Access Compliance Report

Public Rights-of-Way

(Curb Ramps)

Intersection ID: 28300	Main Street: CASTLEBAY_DR	Cross Street: EGERTON_DR	Location: NE
ADA ID: A7B61DCA5473	Ramp Type: Perp	Initial Pass/Fail: Fail	Overall Compliance: No
Severity Score: 12.5			
Codes/Mitigation Info/Possible Solution		Field Measurements/Component Compliance

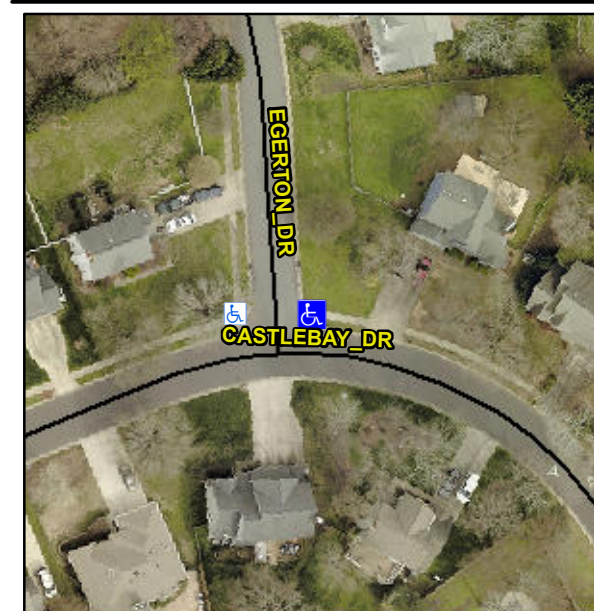
Not Found, R304.2.2

Compliance	Description	Data	Compliance	Description	Data
N/A	Ramp Length (in)	60.0	No	Ramp Slope (%)	8.9
Yes	Ramp Width (in)	48.0	Yes	Ramp XSlope (%)	1.1
N/A	Flare Type LT	N/A	N/A	Flare Type RT	N/A
N/A	Flare Slope LT (%)	N/A	N/A	Flare Slope RT (%)	N/A
N/A	Flare Traversable LT?	N/A	N/A	Flare Traversable RT?	N/A
N/A	Landing Length (in)	N/A	N/A	DWS Provided?	N/A
N/A	Landing Width (in)	N/A	N/A	DWS Contrast?	N/A
N/A	Landing Slope (%)	N/A	N/A	DWS Length (in)	N/A
N/A	Landing X Slope (%)	N/A	N/A	DWS Full Width?	N/A
N/A	Landing Curb? (Y/N)	N/A	N/A	DWS Offset (in)	N/A
N/A	Shared Landing?	N/A			
N/A	Gutter Ponding?	N/A	N/A	Gutter Slope (%)	N/A
N/A	Gutter Lip Ht (in)	N/A	N/A	Gutter X Slope (%)	N/A
N/A	Painted X Walk1?	No	N/A	Painted X Walk2?	N/A
	X Walk 1 Direction	To W		X Walk 2 Direction	N/A
N/A	X Walk 1 Width (in)	N/A	N/A	X Walk 2 Width (in)	N/A
	X Walk 1 Slope (%)	2.8		X Walk 2 Slope (%)	N/A
	X Walk 1 X Slope (%)	0.6		X Walk 2 X Slope (%)	N/A

Remove & Replace Entire Ramp.
